Final Environmental Statement

related to the operation of
**Shearon Harris Nuclear Power Plant,
Units 1 and 2**

Docket Nos. STN 50-400 and STN 50-401

October 1983

Figure 4.1 Station water use (Source: ER-0L Figure 3.3-1)

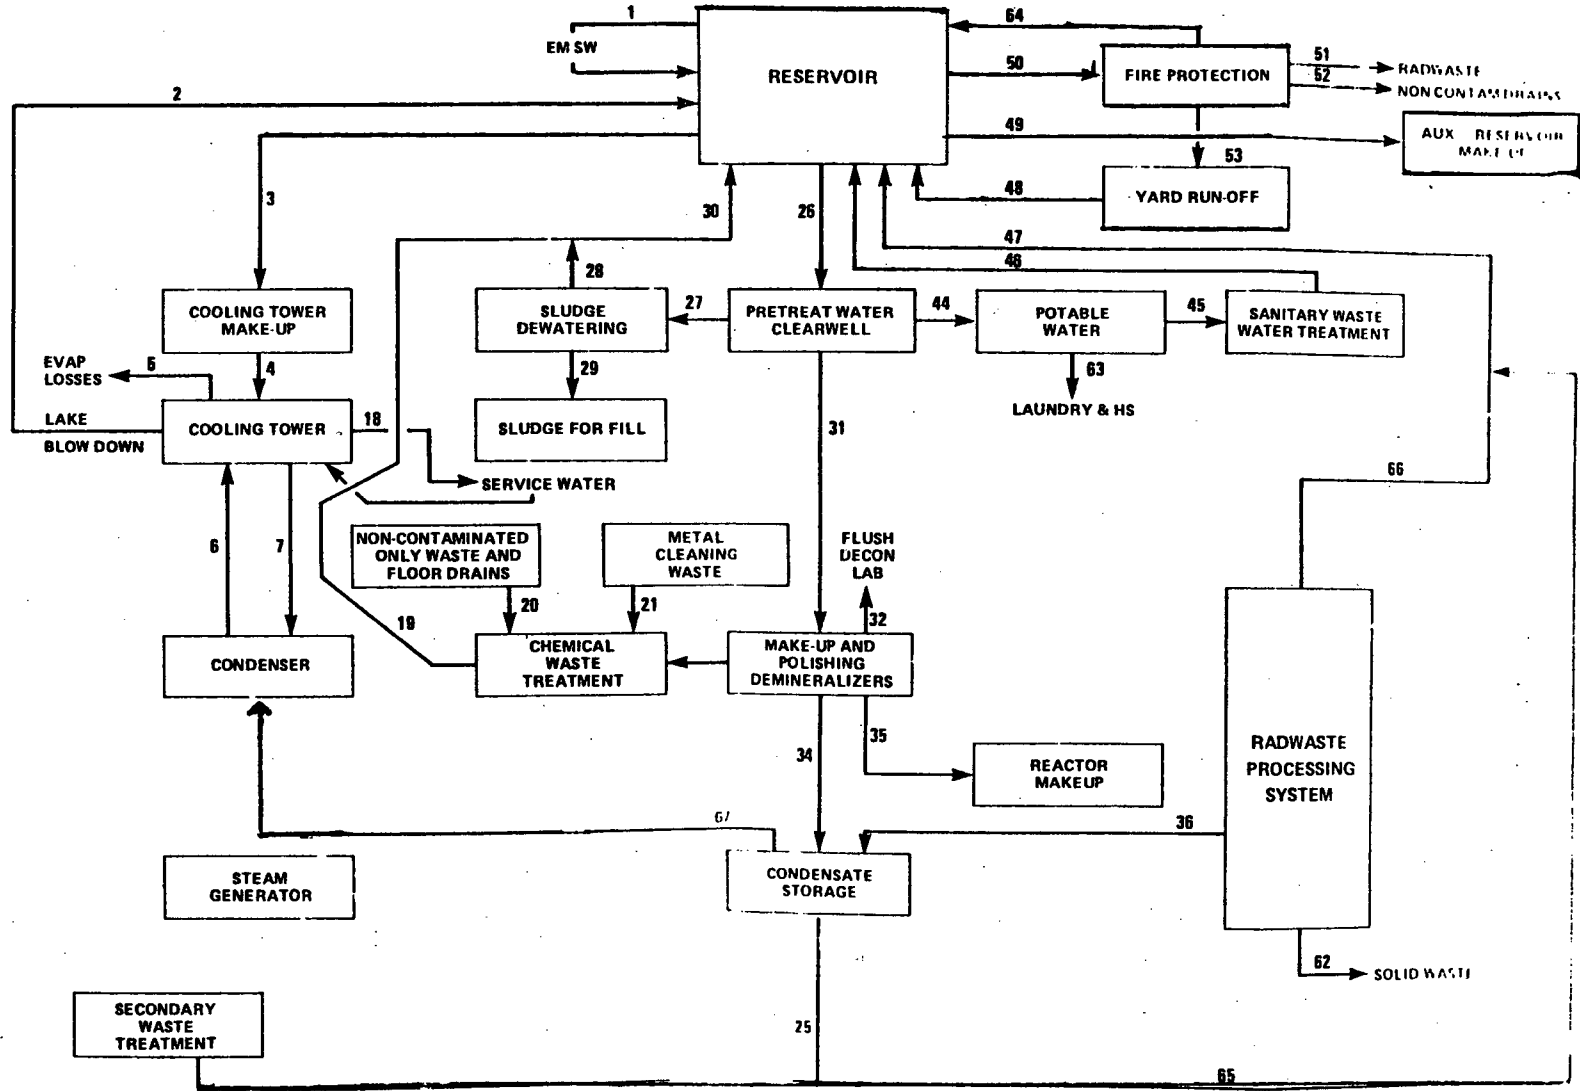
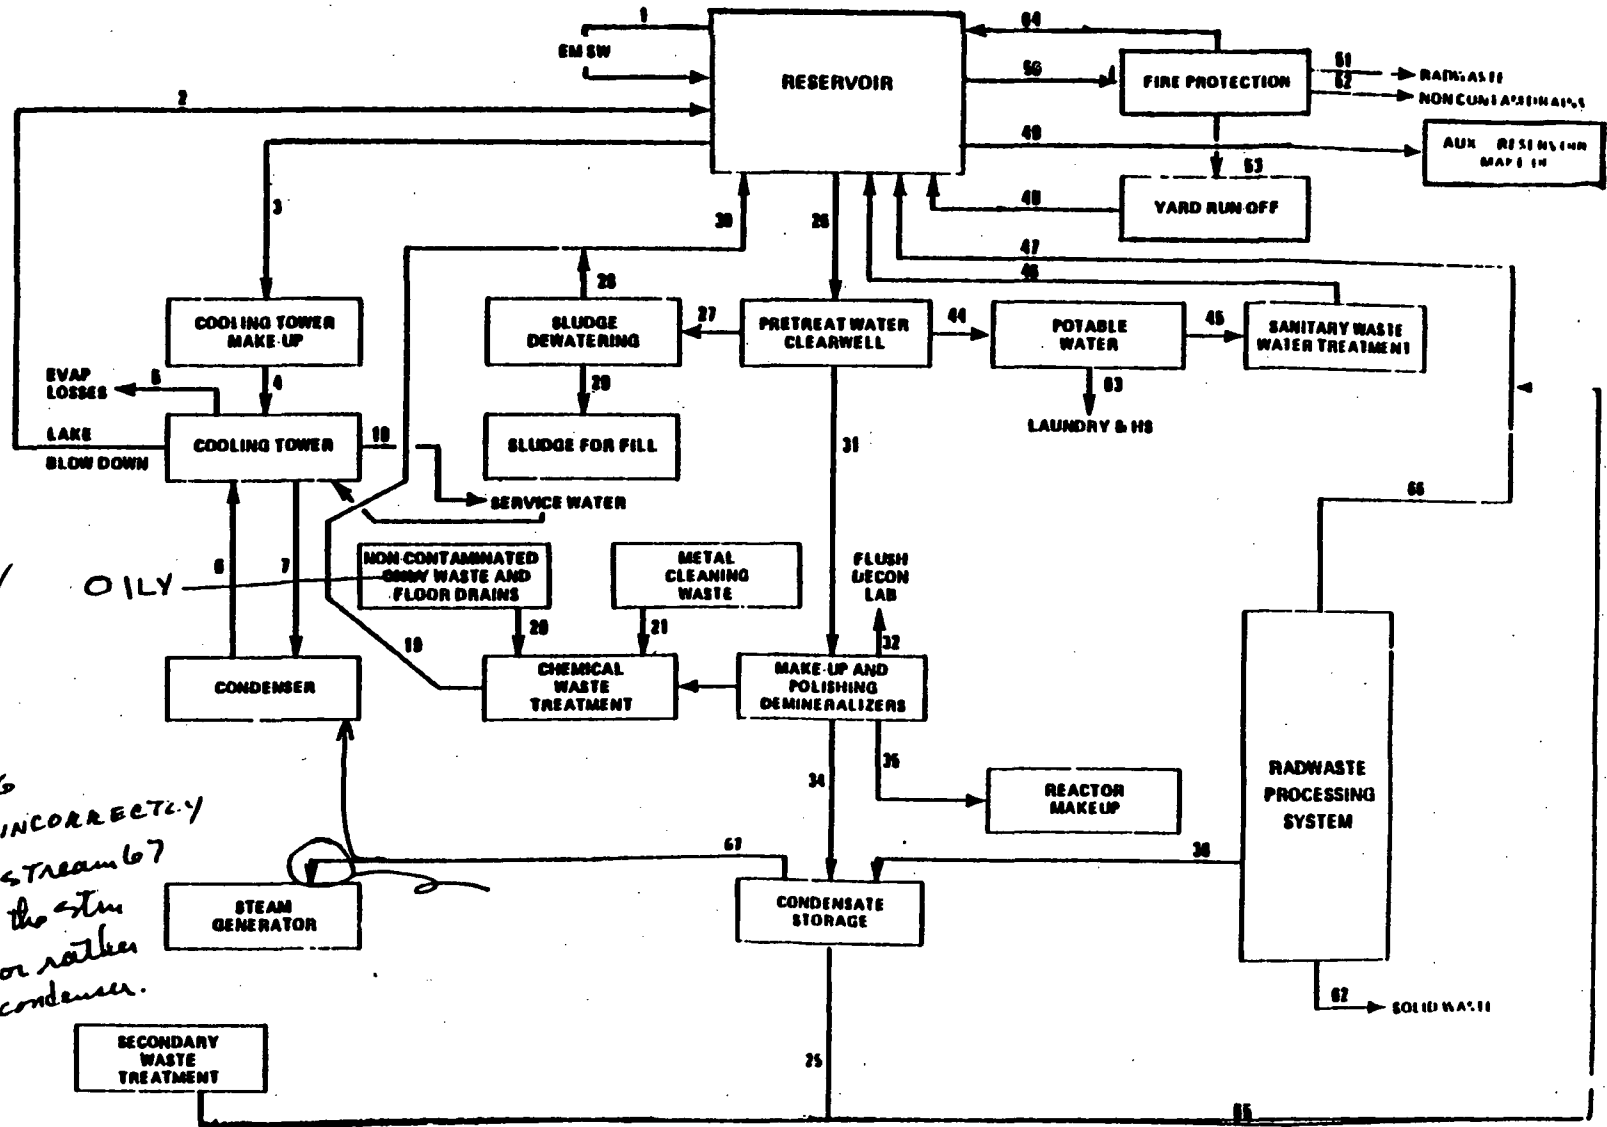
CP&L-18: CP&L noted that Figure 4.1 should be changed to show that condensate is routed to the condenser rather than the steam generator. This has been done.

ER FIG 3.3-1 INCORRECTLY SHOWS stream 67 going to the steam generator rather than the condenser.

Figure 5.8 Probability distributions of individual dose impacts (see Section 5.9.4.5(7) for a discussion of uncertainties in risk estimates)

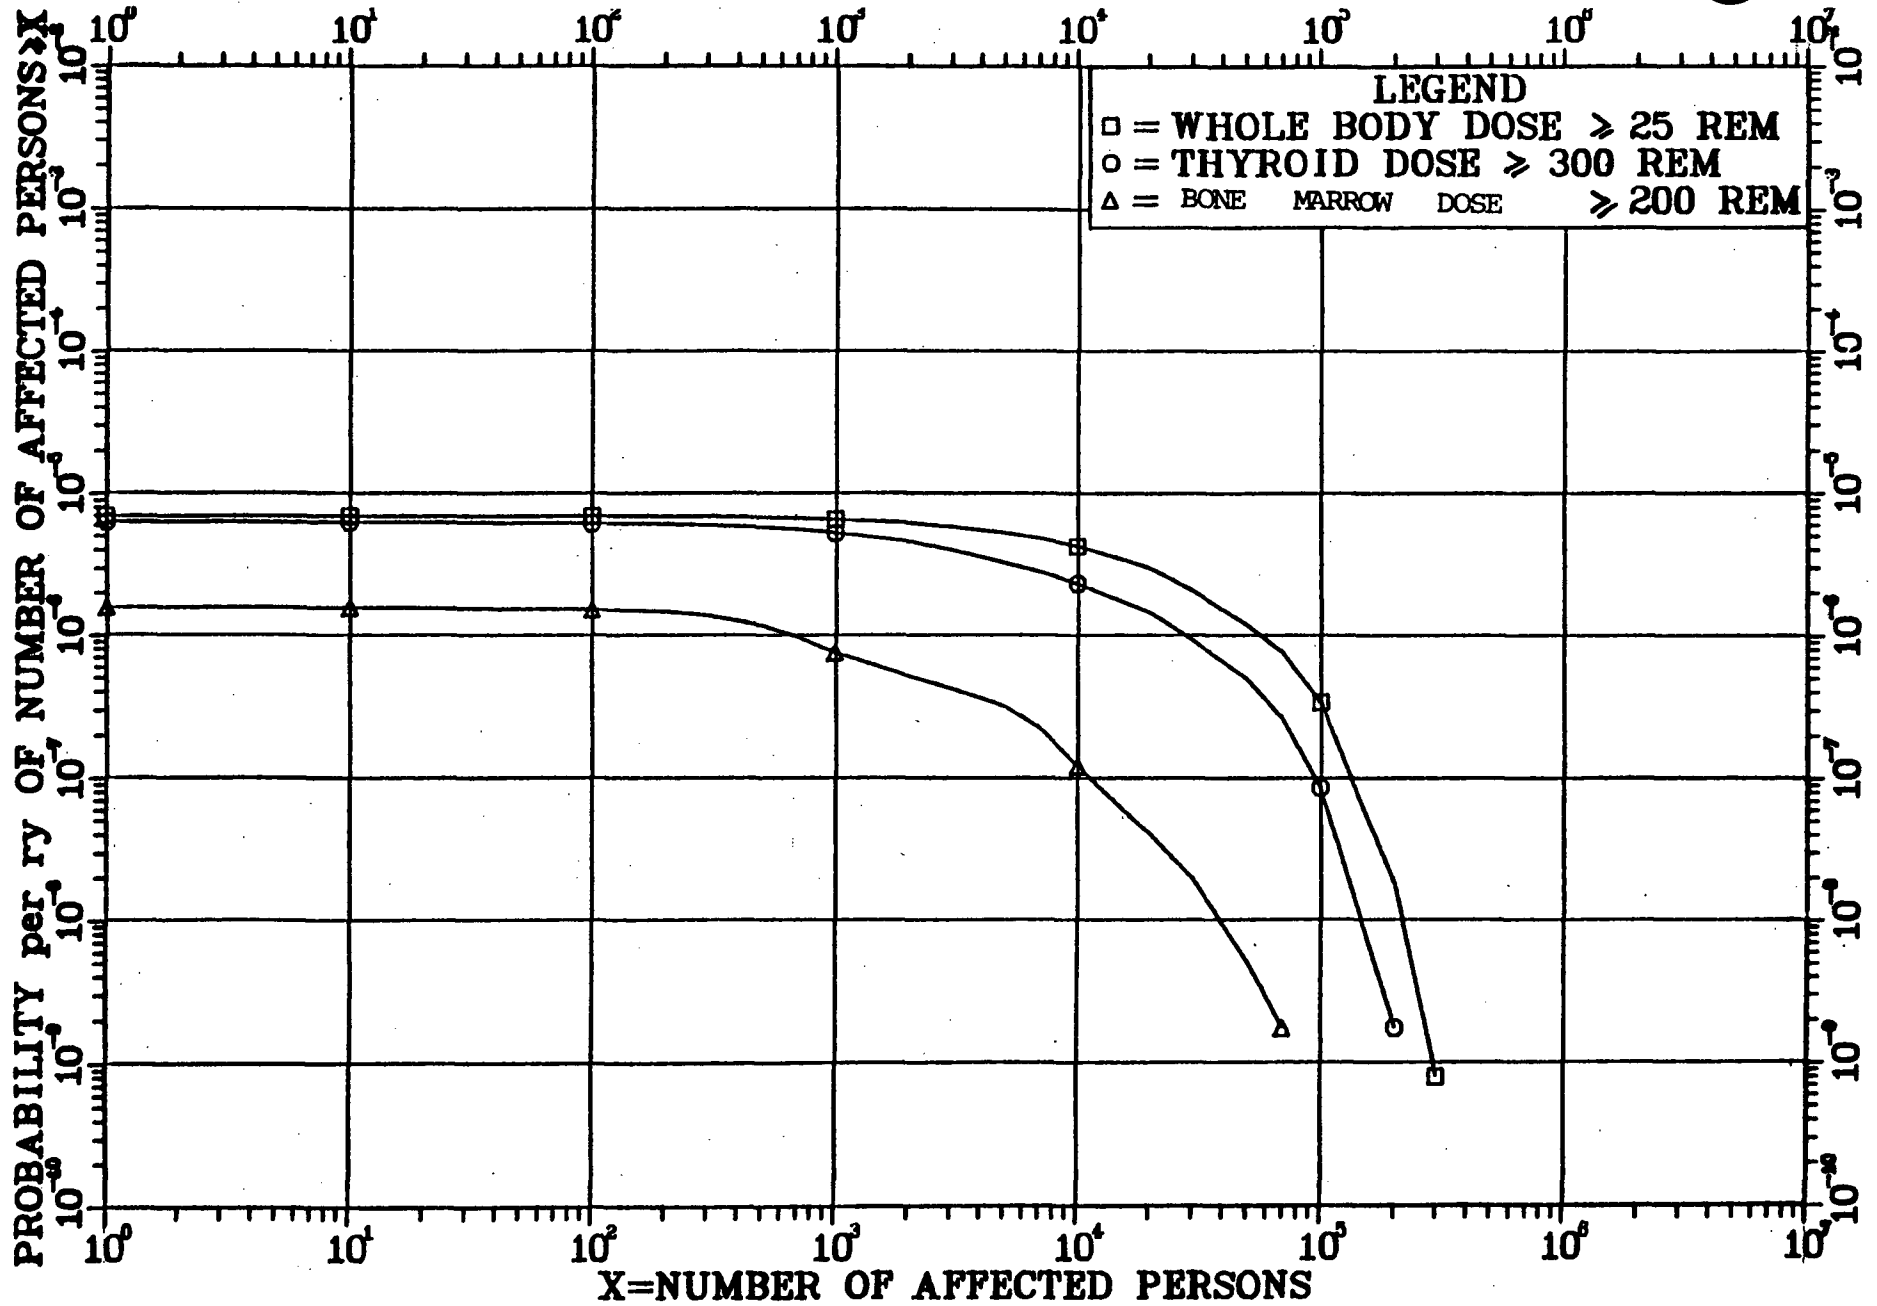
PL-3: Dr. Lotchin commented that Figure 5.8 and others are unreadable by a lay person.
